Intersection ID: 10019990	Main Street: ARMORY_DR	Cross Street: N/A	Location:	SE
ADA ID: 20354E9CF18A	Ramp Type: Perp	Initial Pass/Fail: Fail	Overall Compliance: No	Severity Score: 12.5

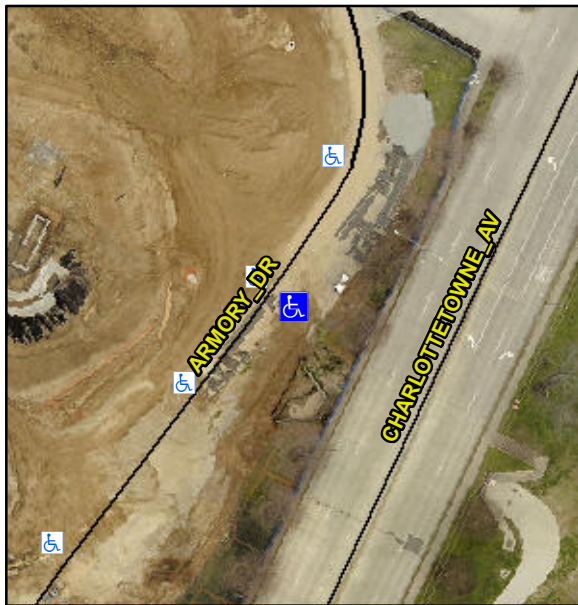
Not Found, R304.2.2

Compliance	Description	Data	Compliance	Description	Data
N/A	Ramp Length (in)	48.0	No	Ramp Slope (%)	8.9
Yes	Ramp Width (in)	48.0	Yes	Ramp XSlope (%)	2.0
N/A	Flare Type LT	N/A	N/A	Flare Type RT	N/A
N/A	Flare Slope LT (%)	N/A	N/A	Flare Slope RT (%)	N/A
N/A	Flare Traversable LT?	N/A	N/A	Flare Traversable RT?	N/A
N/A	Landing Length (in)	N/A	N/A	DWS Provided?	N/A
N/A	Landing Width (in)	N/A	N/A	DWS Contrast?	N/A
N/A	Landing Slope (%)	N/A	N/A	DWS Length (in)	N/A
N/A	Landing X Slope (%)	N/A	N/A	DWS Full Width?	N/A
N/A	Landing Curb? (Y/N)	N/A	N/A	DWS Offset (in)	N/A
N/A	Shared Landing?	N/A			
N/A	Gutter Ponding?	N/A	N/A	Gutter Slope (%)	N/A
N/A	Gutter Lip Ht (in)	N/A	N/A	Gutter X Slope (%)	N/A
N/A	Painted X Walk1?	Yes	N/A	Painted X Walk2?	N/A
	X Walk 1 Direction	To NW		X Walk 2 Direction	N/A
N/A	X Walk 1 Width (in)	72.0	N/A	X Walk 2 Width (in)	N/A
	X Walk 1 Slope (%)	3.8		X Walk 2 Slope (%)	N/A
	X Walk 1 X Slope (%)	2.5		X Walk 2 X Slope (%)	N/A

Remove & Replace Entire Ramp.
